**RE: CONTRACT NO.: 13/WSD/17
DESIGN, BUILD AND OPERATE FIRST STAGE OF TSEUNG KWAN O
DESALINATION PLANT
Submission of Detailed Design Plan for Chlorine and Carbon Dioxide Storage
of Desalination Plant**

Detailed Design Plan for Chlorine and Carbon Dioxide Storage of Desalination Plant

Contract No. 13/WSD/17 Design, Build and Operate First Stage of Tseung Kwan O Desalination Plant

Submission No.	TKOD1-RPT-A000-JGN0003-04		
Subject	Submission of Detailed Design Plan for Chlorine and Carbon Dioxide Storage of Desalination Plant	Date	9/07/2021
Version	04	Page	1 of 2

Figure 2: Building Separation Distances

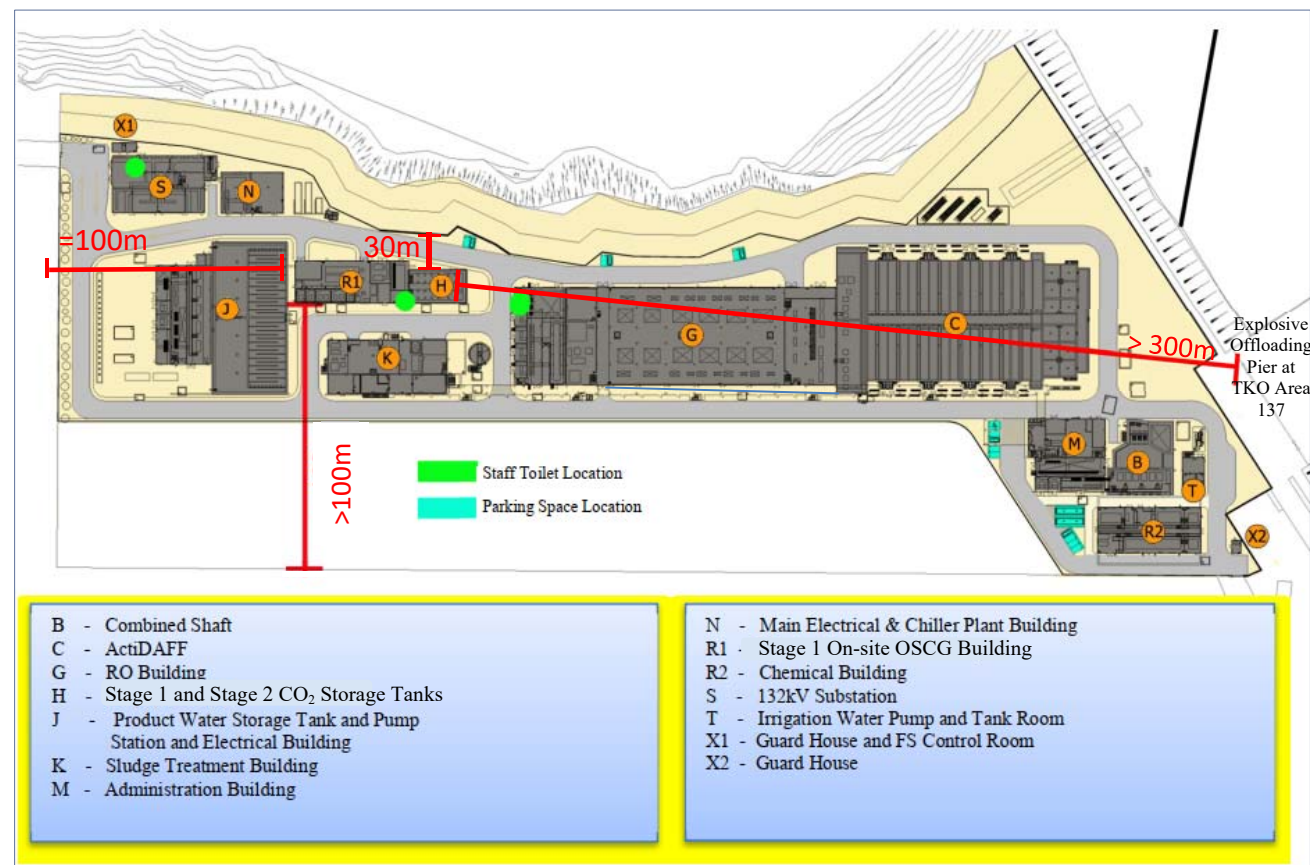
6. Figure 1 shows that the OSCG plant is “<100m” from the boundary. Please check. Also, please check the distance between the OSCG plant and the northern boundary of the desalination plant.	The OSCG plant is “>100m” from both the western and northern site boundary as per updated current design. Please refer to Appendix B-1 for detailed location.

Appendix B - 2: Process & Instrumentation Diagrams (P&IDs) of Remineralisation CO₂ Storage Tanks and Related Systems

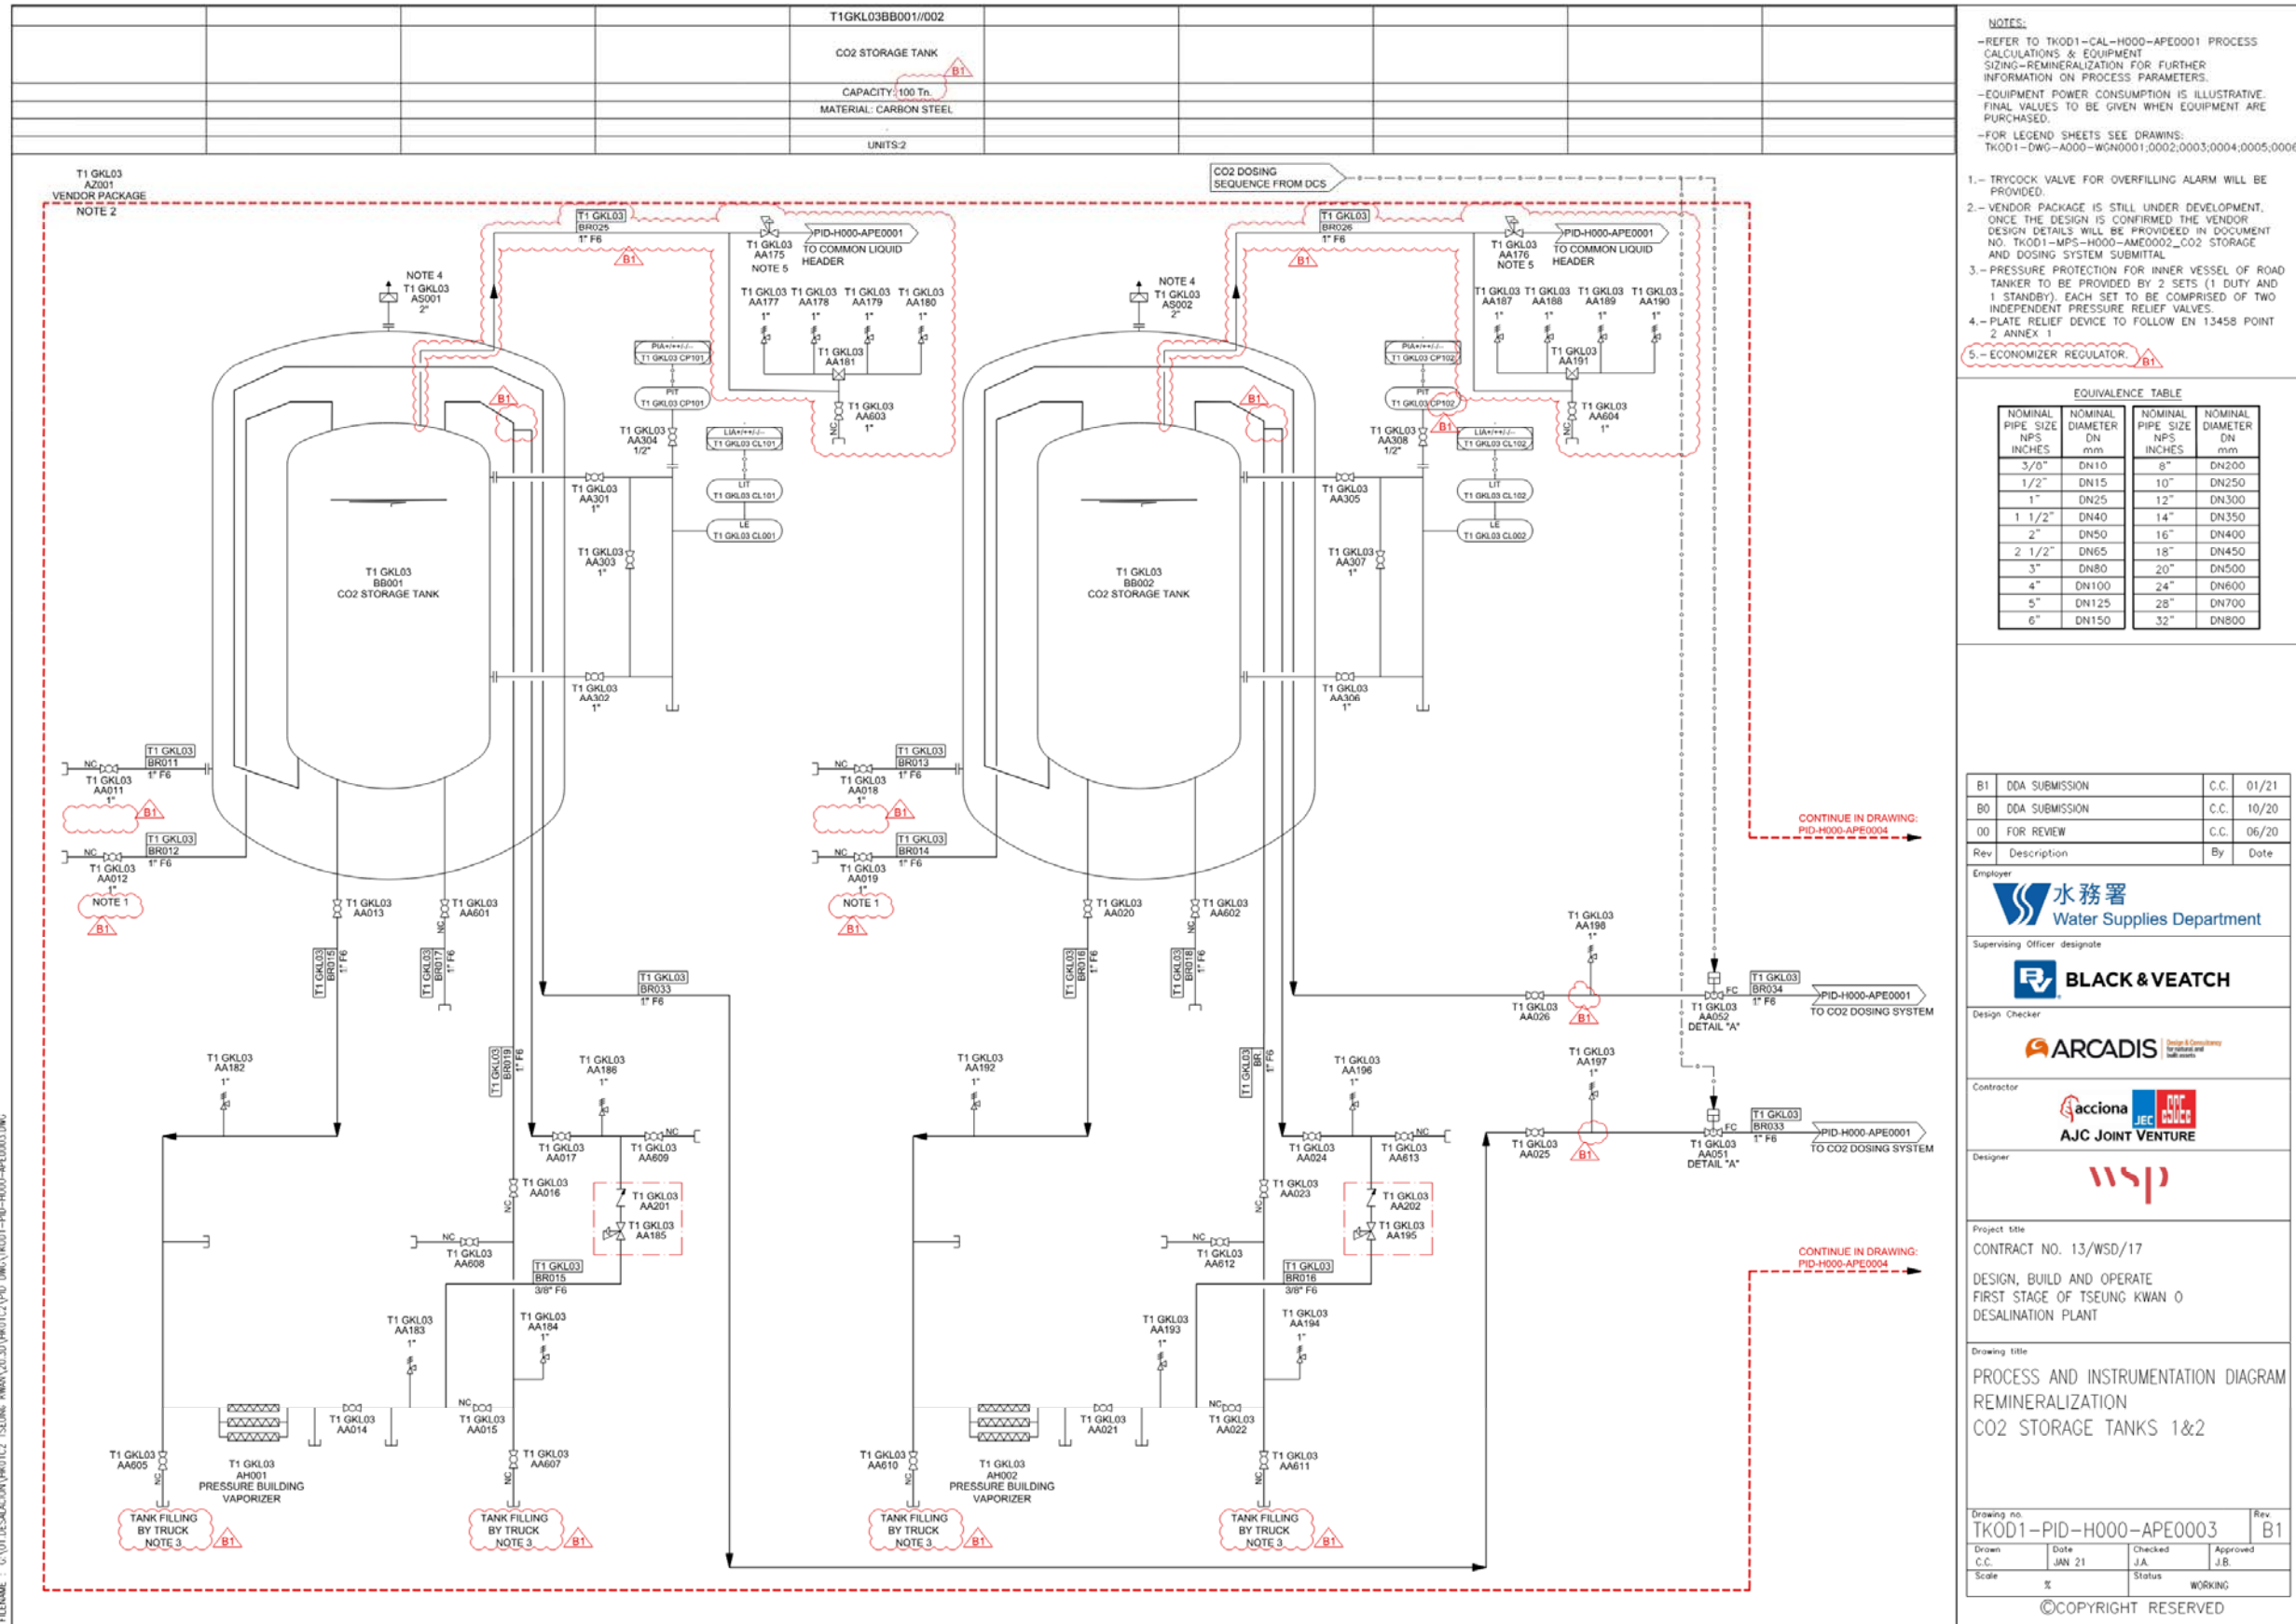
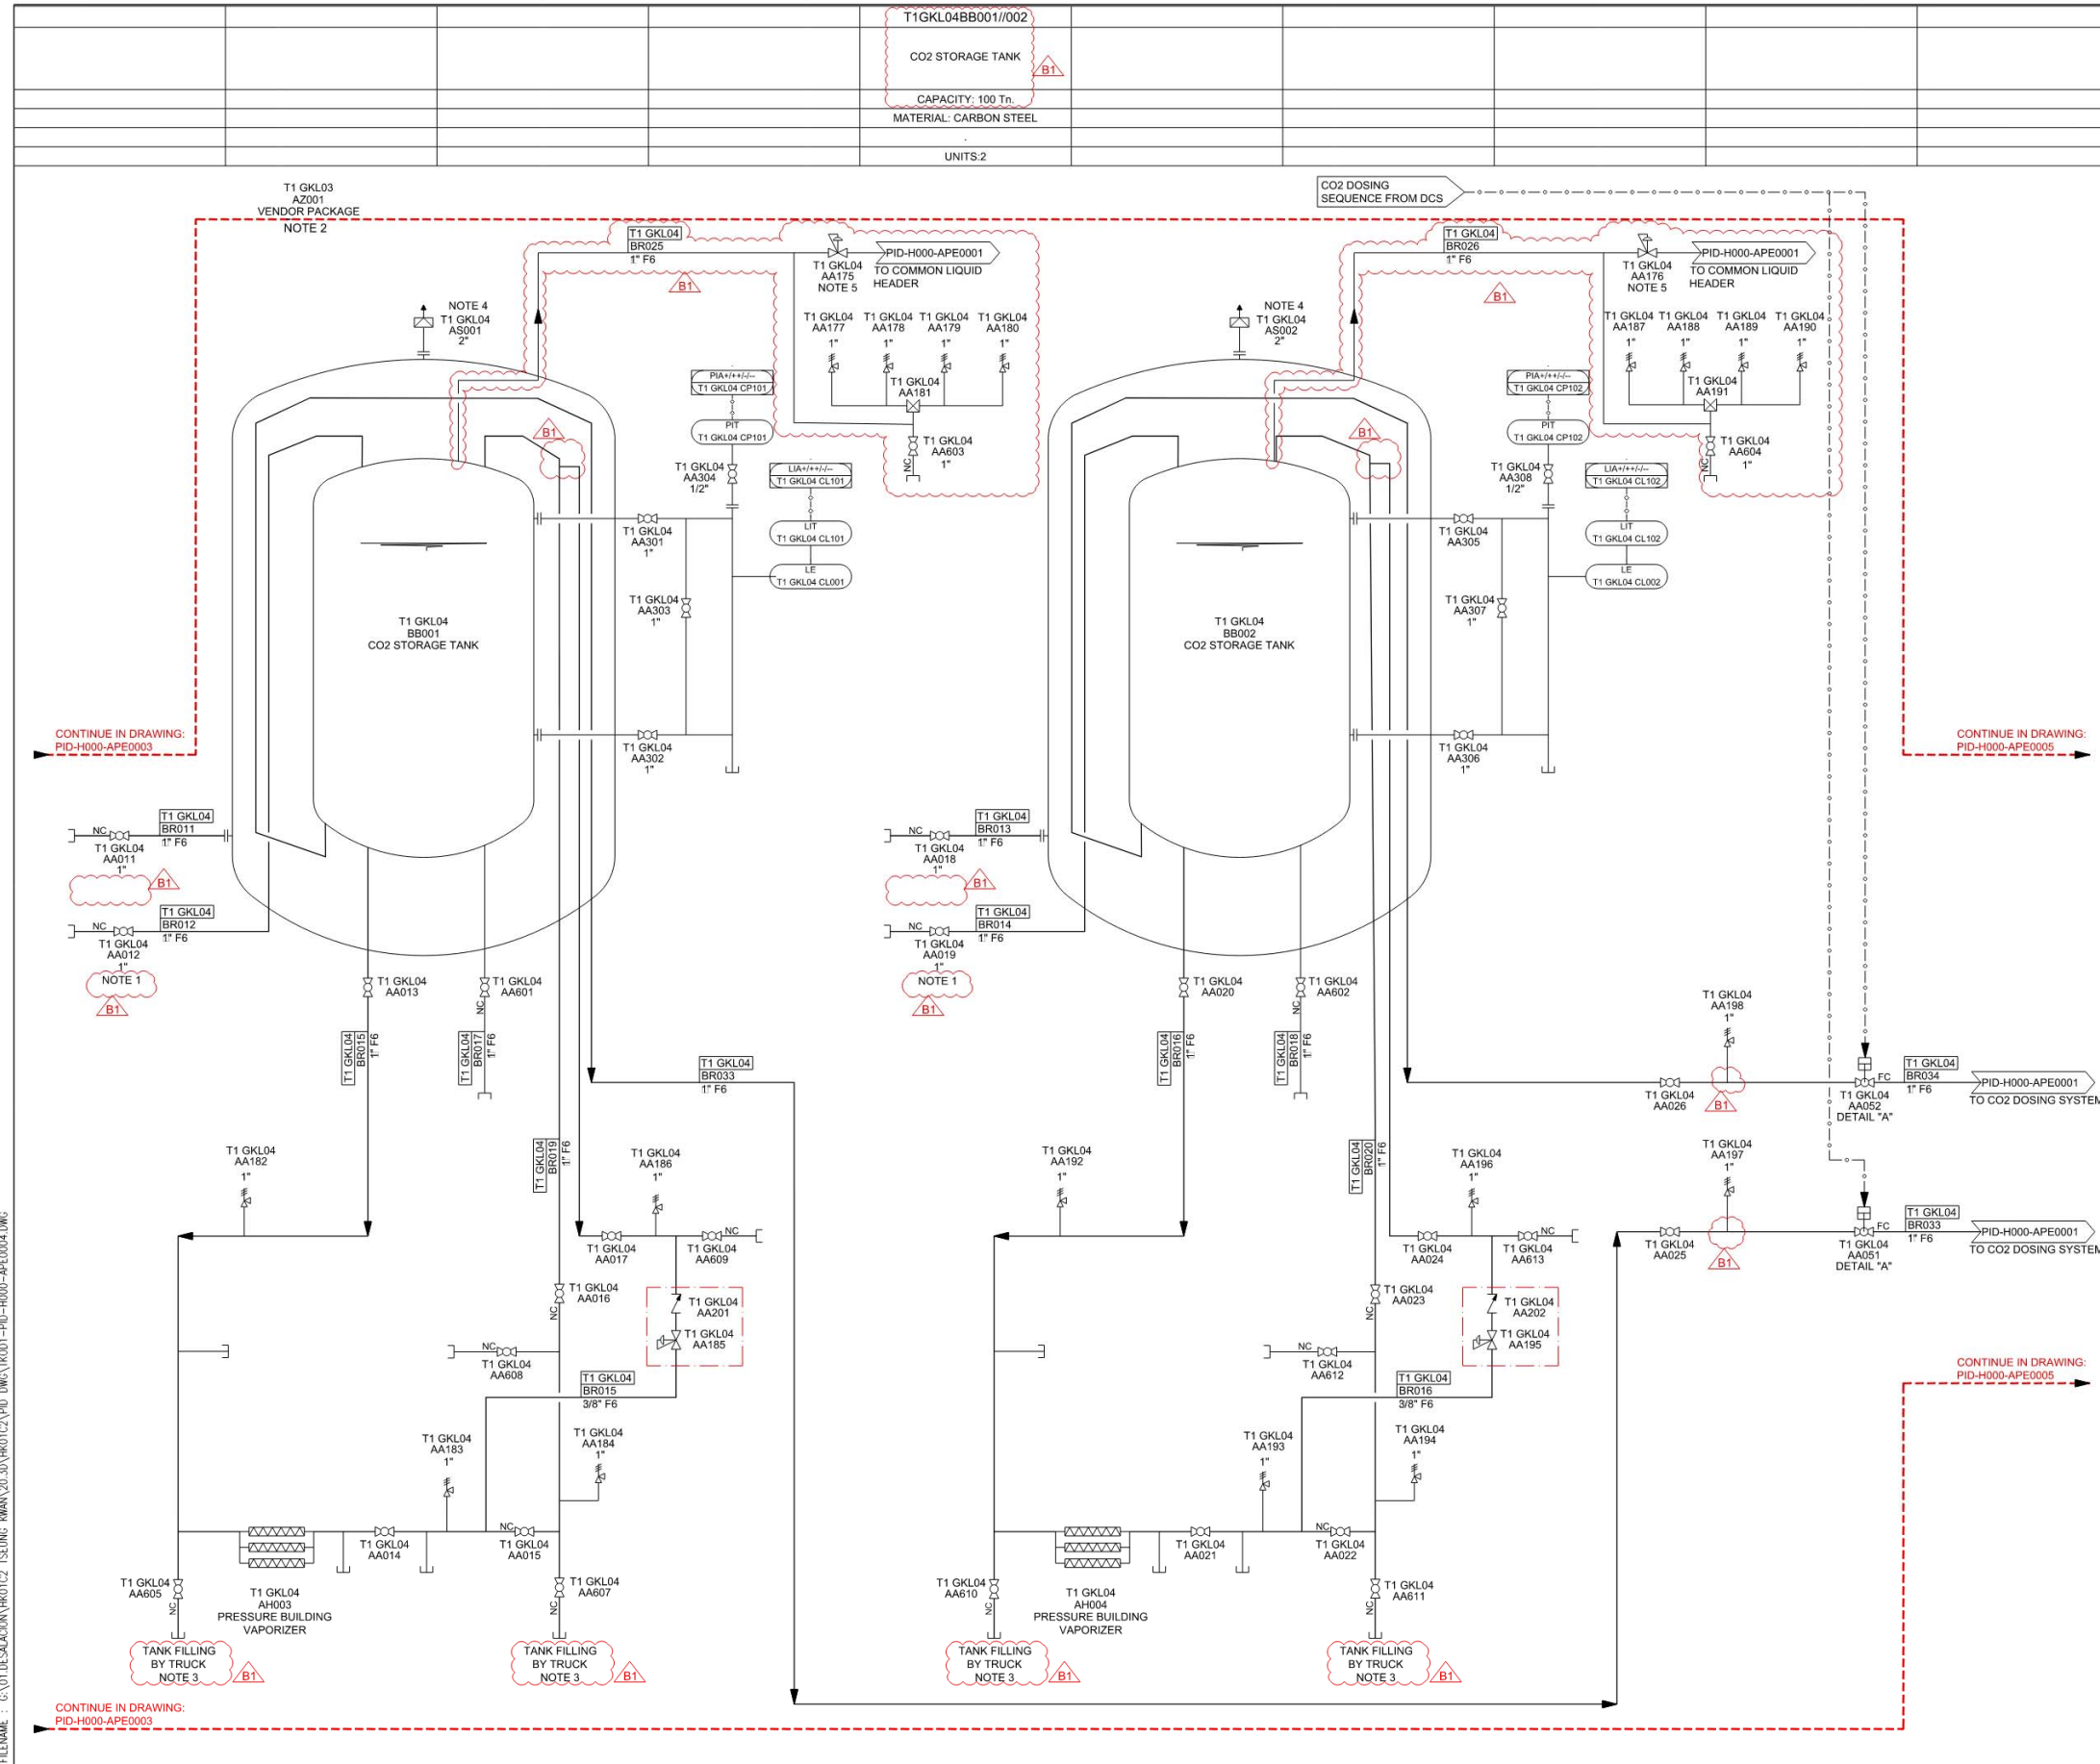
2. Appendix B Please explain how the design of the pressure relief valves system can avoid common mode failure.	Explanation has been added in Appendix B-5 of the revised plan. The P&IDs in Appendix B-2 have also been revised.
